REMARKS

Amendments to the Drawings

Annotated Sheets Showing Changes

FIG. 1

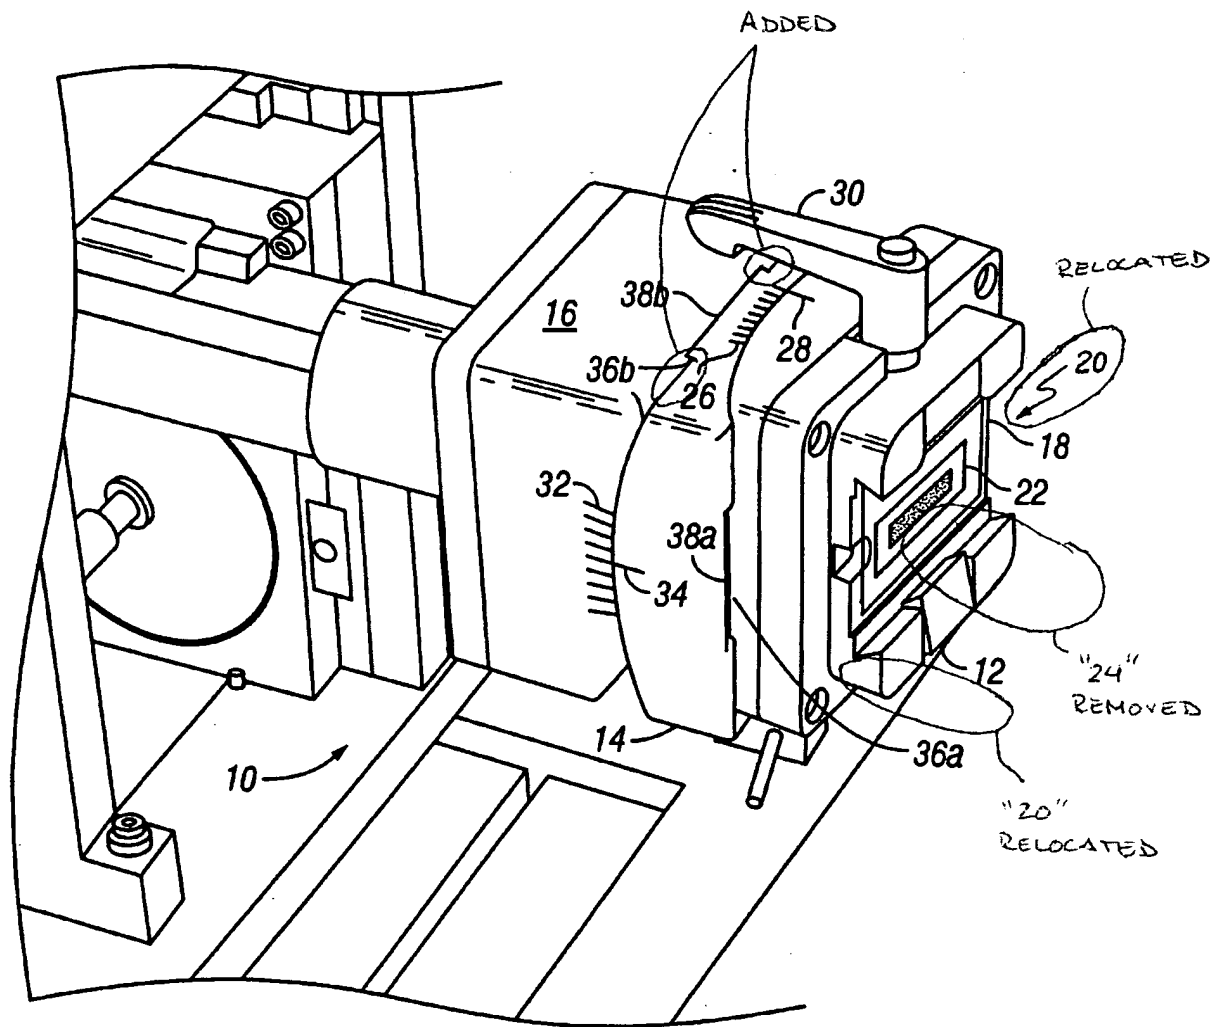
The attached sheets of drawings includes changes to Figures 1 and 2. In Figure 1, line segments were added to properly show a complete interface between second portion (14) and third portion (16), reference number “24” was removed because it was not discussed in the specification and reference number “20” was relocated to properly show the cutting region (20). In Figure 2, a line segment was removed to properly show the interface between first portion (12) and second portion (14), line segments were added to correct the interface between second portion (14) and third portion (16), reference number “24” was removed and reference number “20” was relocated. In addition, an error in the depiction of the support structure for the multi-axis chuck was corrected to make it consistent with that structure as depicted in Figure 1. All of the aforementioned corrections are noted in the attached Annotated Sheets.
